**CITY OF DOVER, DELAWARE
PLANNING COMMISSION
Monday, May 20, 2024 at 7:00 PM**

AGENDA

**CITY OF DOVER PLANNING COMMISSION
APRIL 15, 2024**

DATA SHEET FOR SITE PLAN REVIEW

SHT: PP-1

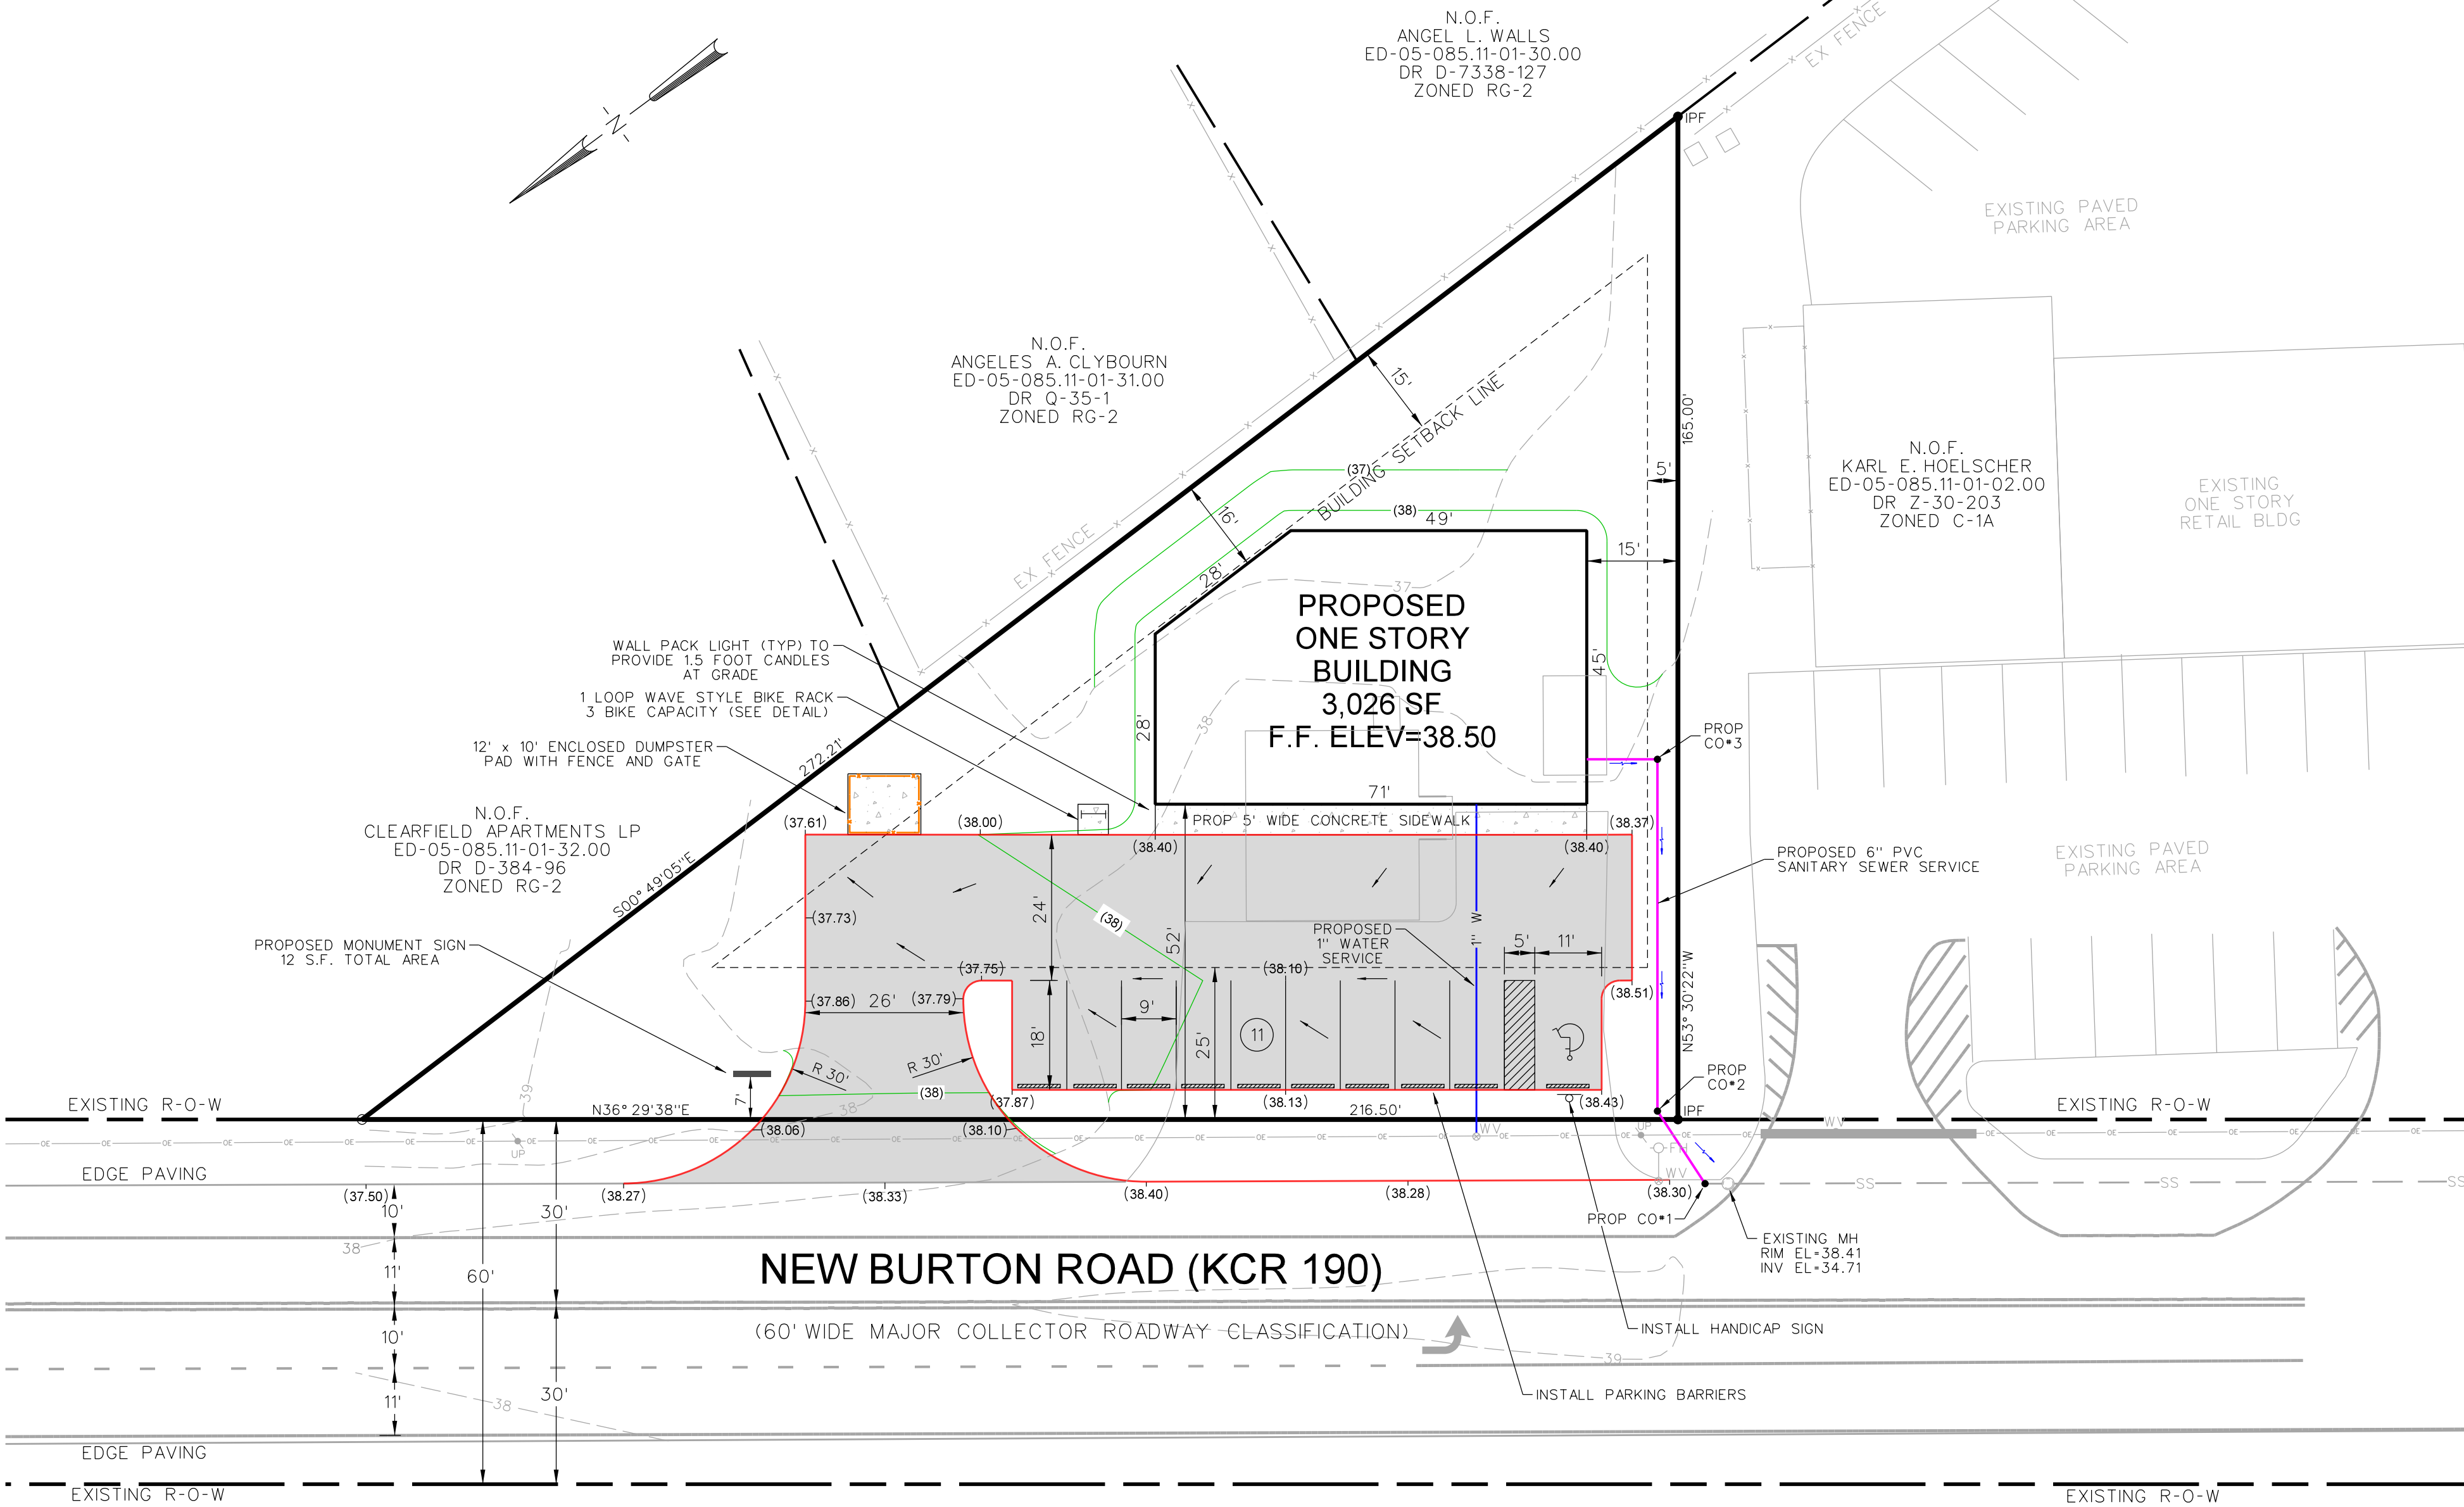
- 4) Sheet 1/Cover Sheet:
 - a) Correct Lot area to 17,861 SF per deed D12544/9, as the plan lists 0.41 acres.
 - b) Correct Floor Area Ratio to 0.169.
 - c) Include the full building height. Change the 12' to 20'.

- d) The 2 properties to the north are zoned R-8 (150 and 154 Haman Rd).
 - e) Please add details for the dumpster pad and enclosure. It should be on the plan, not necessarily on sheet 1. The dumpster enclosure should specify enclosure materials.

Sheet No.:

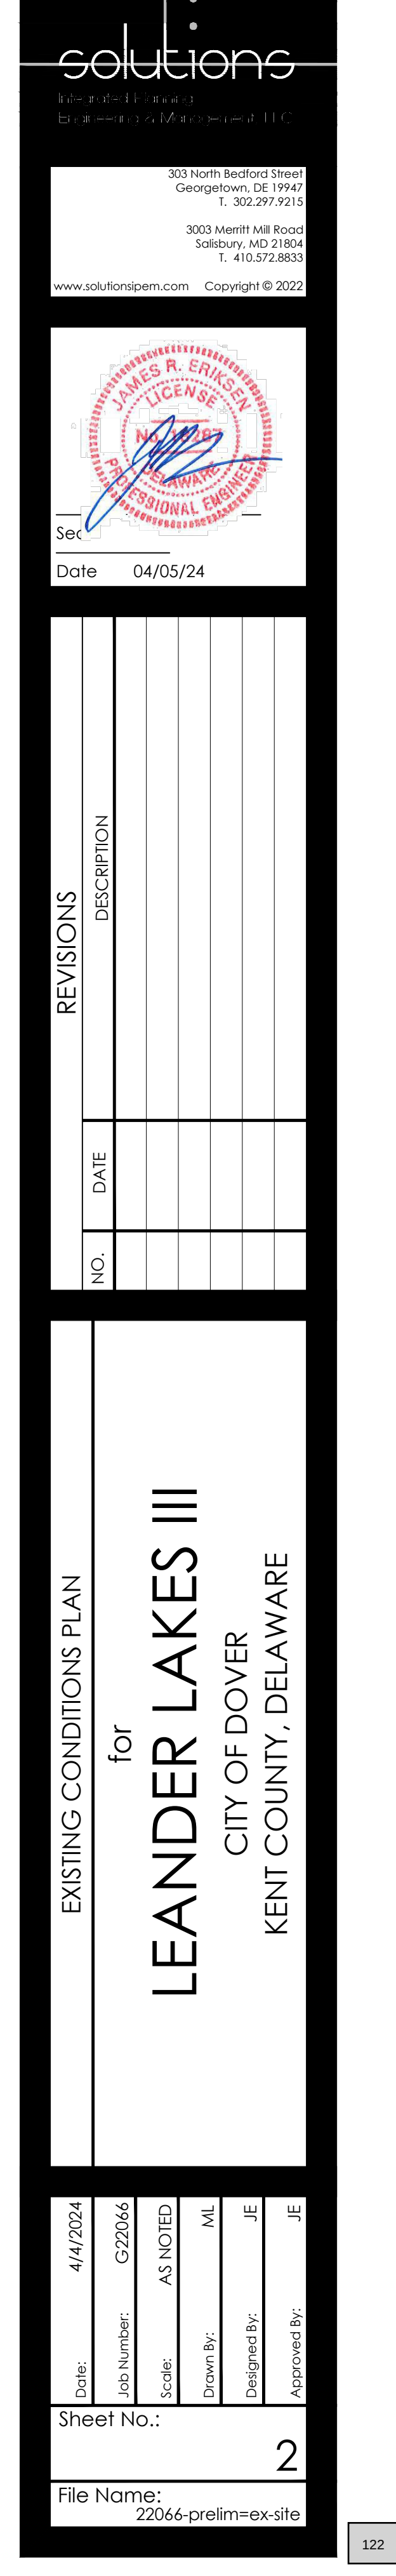
- 3) Sheet 1 – Cover Sheet:
 - a. List updated tax parcel number (when assigned), involved property owners, and addresses of properties.
 - b. Cite source of wetlands delineation; where is signature block?

- c. Match total impervious coverage and lot coverage. It is listed differently.
- 4) Sheet 2 – Existing Conditions Plan: Add addresses to church buildings and properties for clarity.

Sheet No.:	5
File Name:	22066-prelim=land

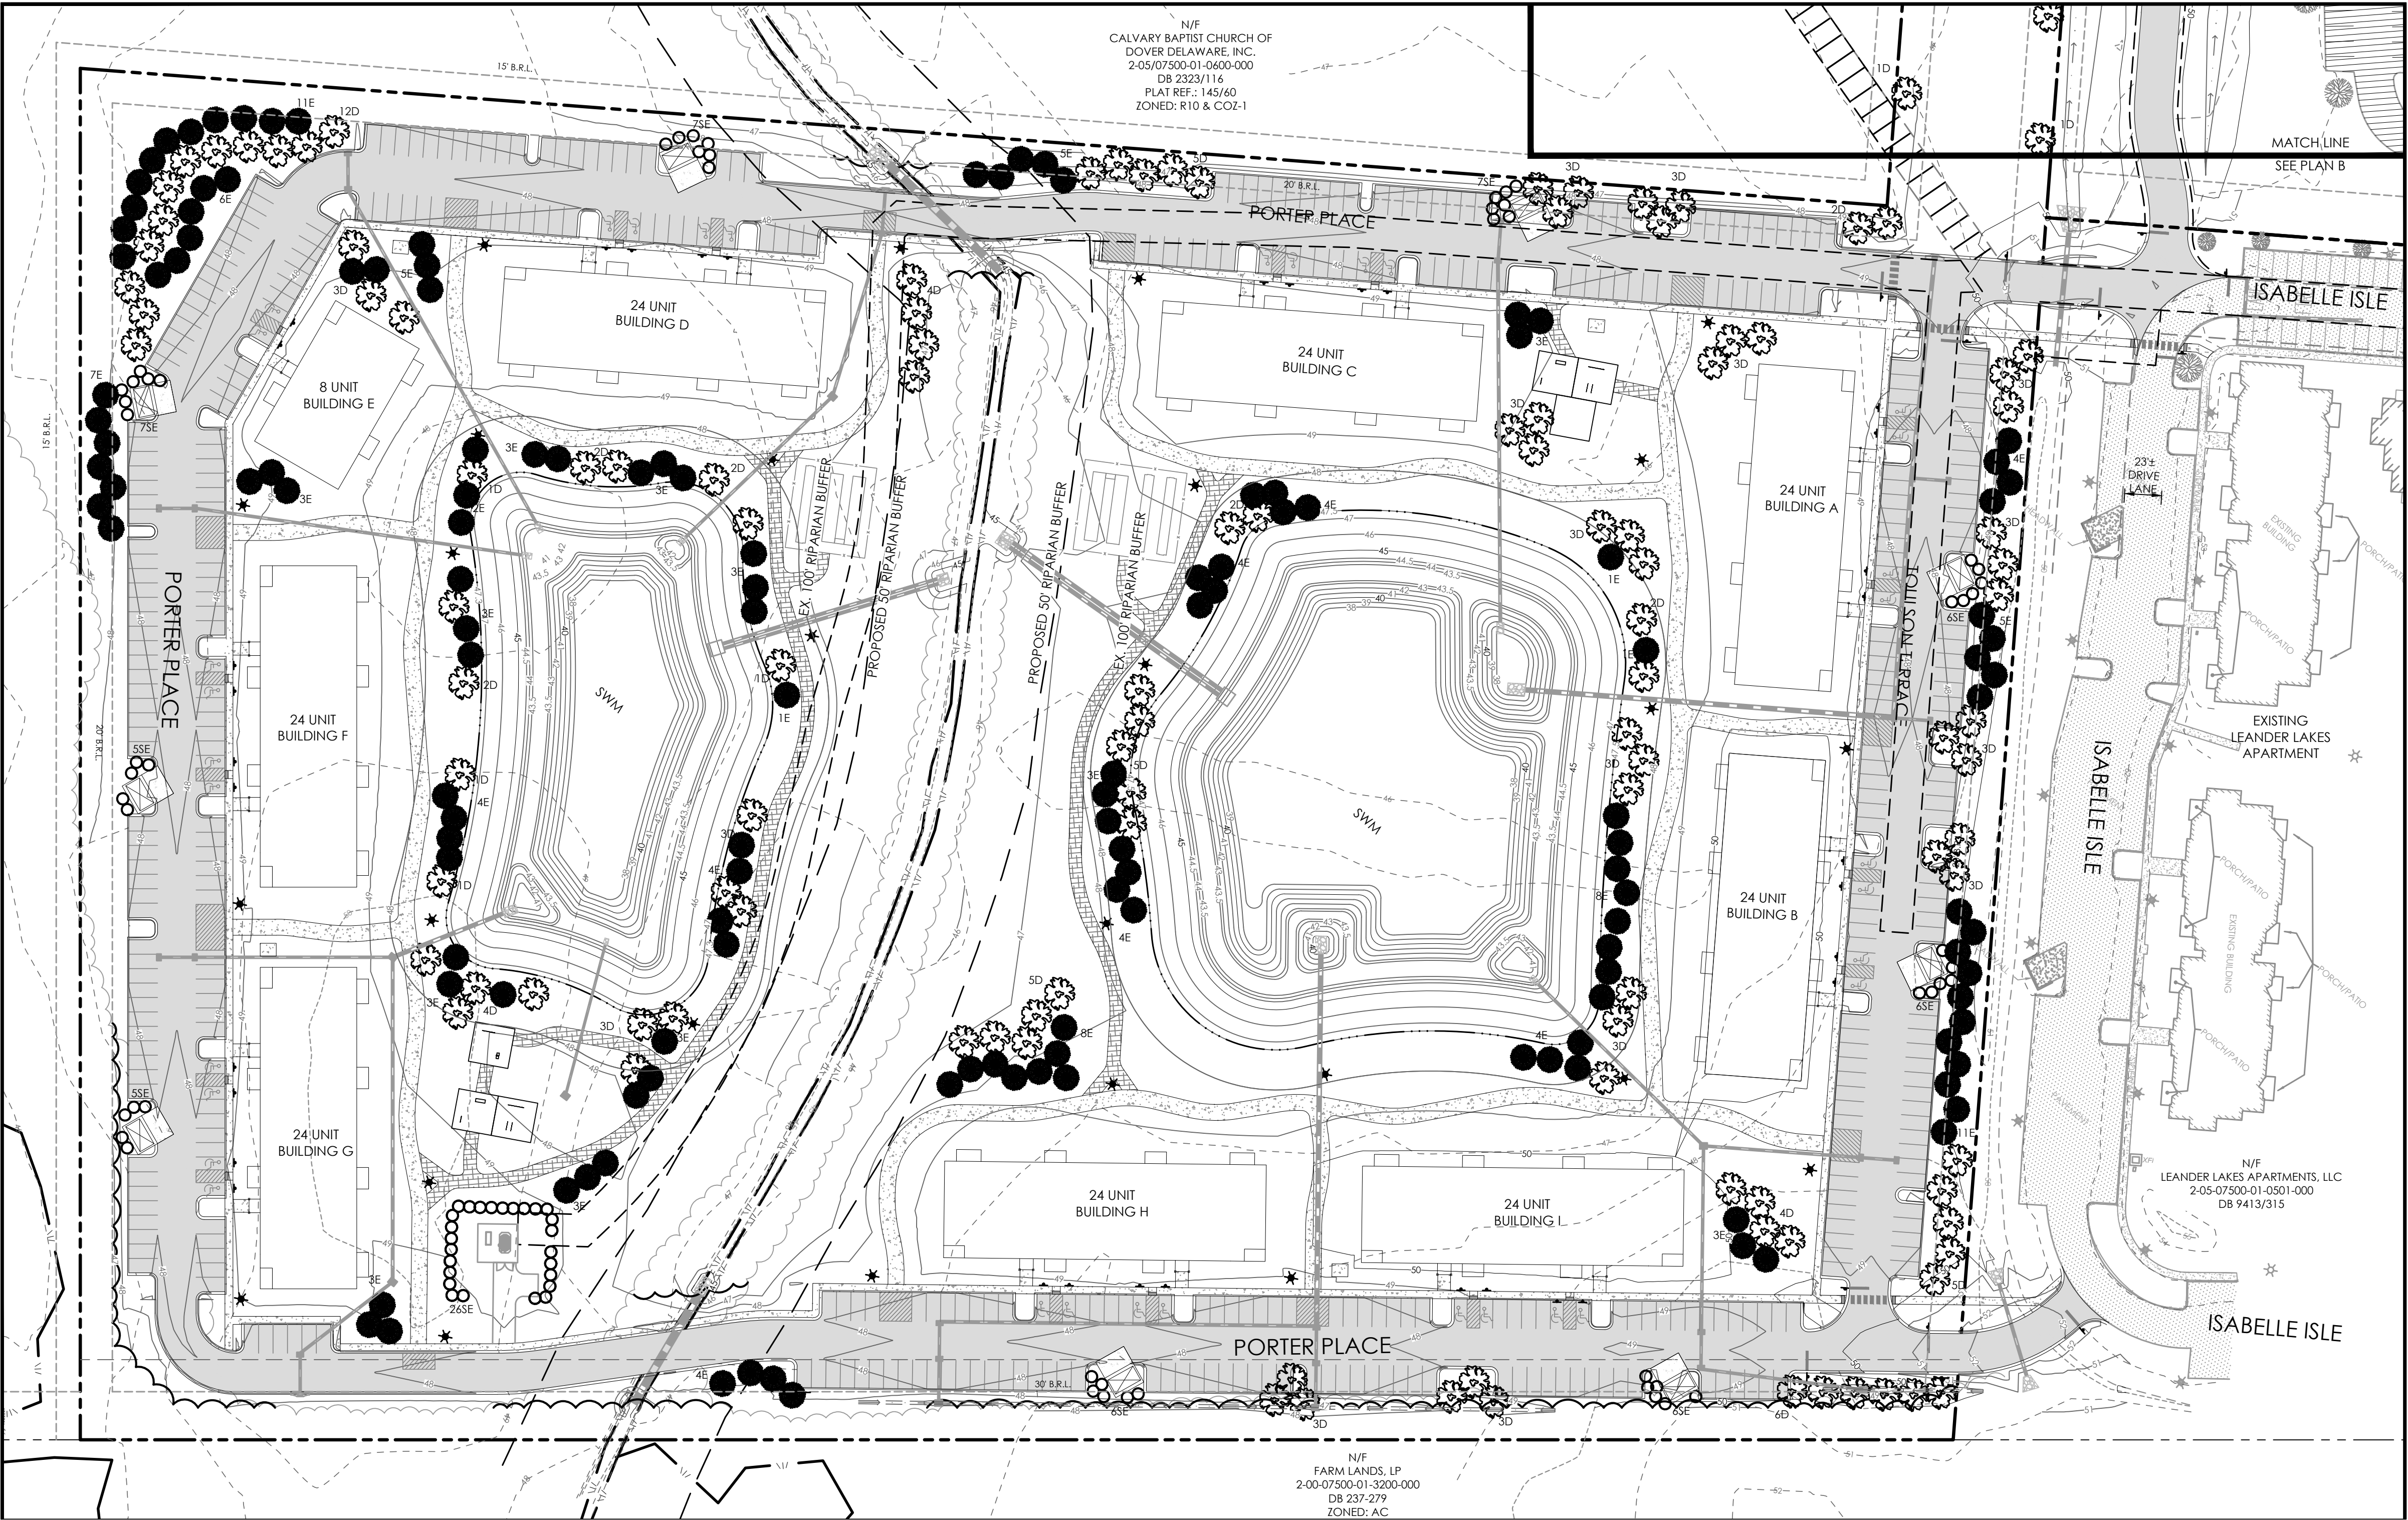
- 8) Sheet 5 and 6 - Preliminary Landscape Plan:
 - a. Identify specific tree species for proposed trees. The tree selection list can be linked to type.
